DELEGATED APPLICATION REPORT

SITE ADDRESS: Great Brighams Mead, Vastern Road, Reading
APPLICATION NUMBER: 220778/DDP
PROPOSAL: Application for prior approval of 72 proposed New dwellinghouses on Detached buildings in commercial or mixed use - Town and Country Planning (General Permitted Development) (England) Order 2015 (as amended) - Schedule 2, Part 20, Class AA, for the proposed additional storeys to result in a maximum overall building height of 21.92m.
EXTENDED TARGET DATE: 02/08/2022

Front of Great Brighams Mead

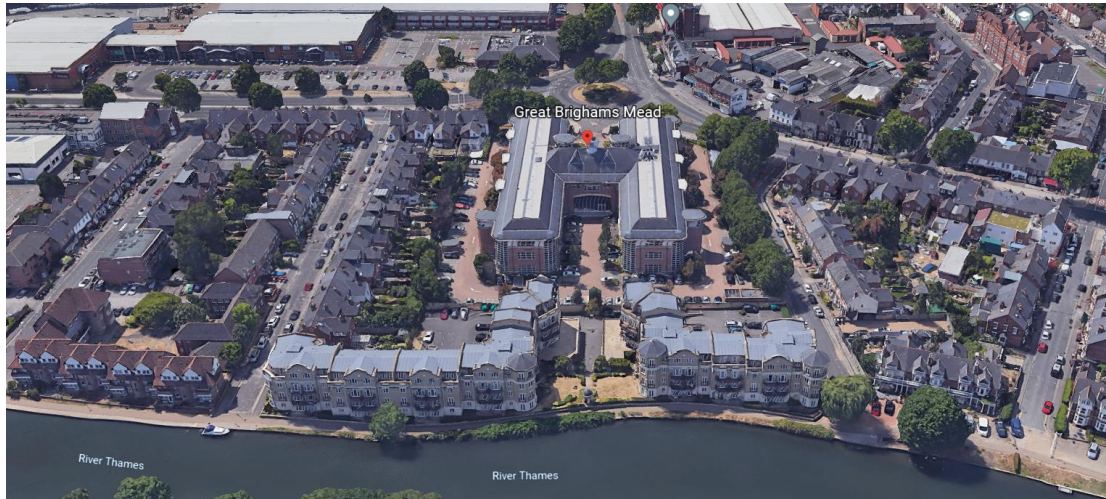
The application site comprises a three-storey office building called Great Brighams Mead with a part brick façade, a hipped roof and a distinctive clocktower in a prominent position within the public realm, surrounded by mature trees to the south and west of the building. The site is located to the north of Reading Train Station, fronting onto the Caversham Road/Vastern Road roundabout. It is on the edge of a residential area comprising terraced Victorian houses and flats to the rear.

Proposed roof terrace at fourth floor level

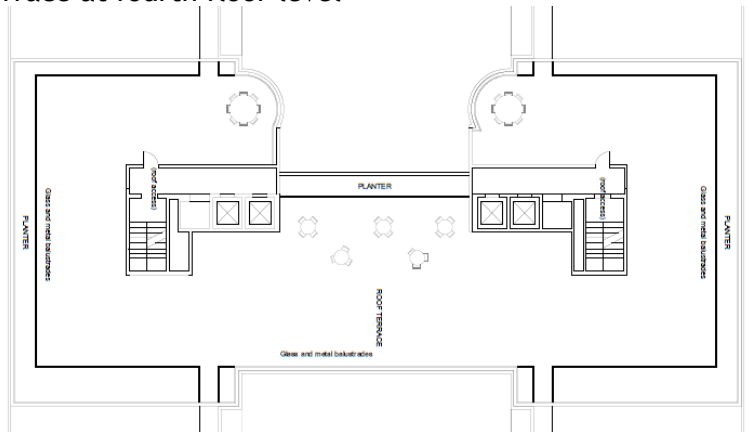
(a) engineering operations reasonably necessary to construct the additional storeys and new dwellinghouses; **Does not comply.** The plans have been assessed and in this instance, it is considered that the proposal comprises more than 2 additional storeys. It is noted that an additional two storeys are proposed to provide 72 new dwellinghouses over and additional 2 floors on top of a detached building in commercial or mixed use, however the use of the roof level is also part of the development as proposed. These rooftop terrace works are considered beyond actions reasonably necessary to construct the two additional storeys.

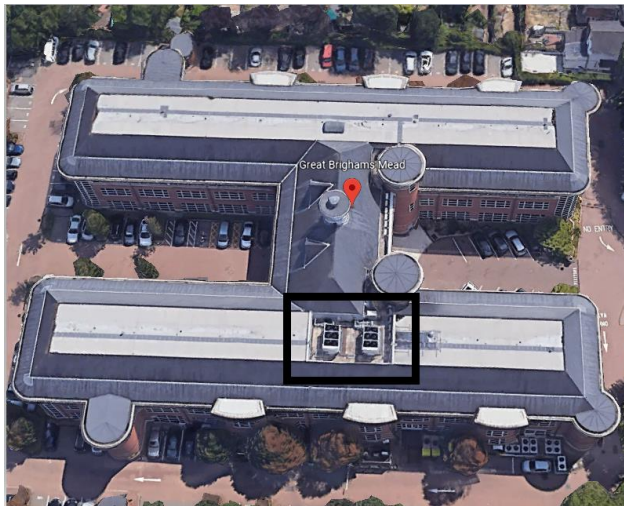
Complies - No engineering operations outside of the existing curtilage are proposed, as confirmed on the drawings and structural report/letter ref. MBP-8632.MB (23 March 2022) from MBP.
